Koseian Property, Preliminary Plan, 120110390

Completed: 4/26/2013

Staff recommends APPROVAL of Preliminary Plan 120110390 with conditions.

Preliminary Plan

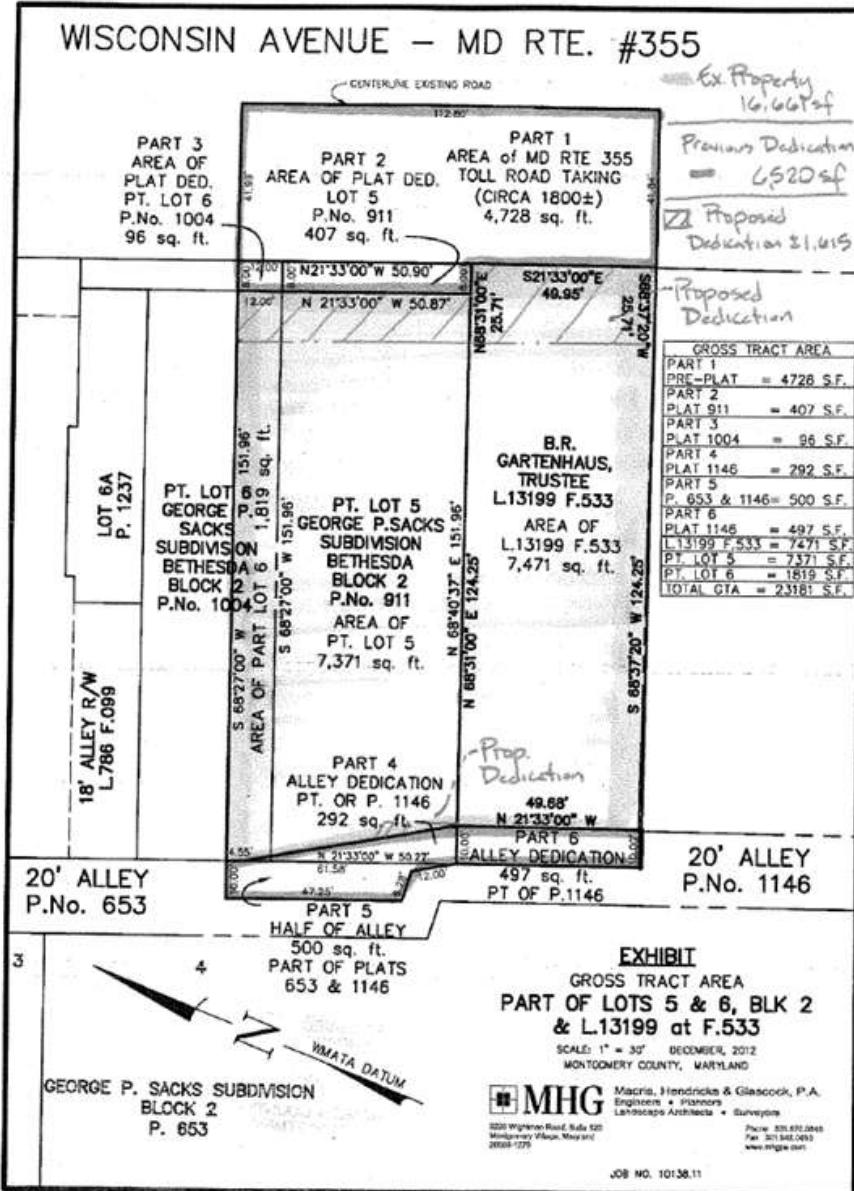
1. Show all existing planimetric and topographic details (paving, storm drainage, driveways adjacent and opposite the site, sidewalks and/or bikeways, bus stops, utilities, etc.) as well as existing rights of way and easements on the preliminary plan.

2. Necessary dedication for future widening of Wisconsin Avenue/MD 355 and the alley in accordance with the master plan and the County Code.
3. Access and improvements along Wisconsin Avenue (MD 355) as required by the Maryland State Highway Administration.

4. Submit storm drain capacity and impact studies (for the enclosed system within the public alley) prior to submission of the record plat. Analyze the capacity of the existing downstream public storm drain system and the impact of the post-development ten (10) year storm runoff on same. If the proposed subdivision drains to an existing closed section street, include spread computations in the impact analysis.

5. Prior to MCDPS approval of the record plat, the applicant will need to submit an updated Sight Distances Evaluation certification form, for the existing and proposed driveway(s), which indicates dumpster and/or other obstacle removal has been completed to achieve a minimum of one hundred and fifty (150) feet of sight distance in each direction for the proposed alley driveway.

6. For safe simultaneous movement of vehicles, we recommend a driveway pavement width of no less than twenty four (24) feet to allow vehicles to enter and exit the site without encroaching on the opposing lanes. This pavement width will permit an inbound lane width of fourteen (14) feet and an exit lane width of ten (10) feet.

8. On the site plan, delineate the location and dimensions of the proposed truck loading and/or dumpster spaces.
9. Provide on-site handicap access facilities, parking spaces, ramps, etc. in accordance with the Americans With Disabilities Act.
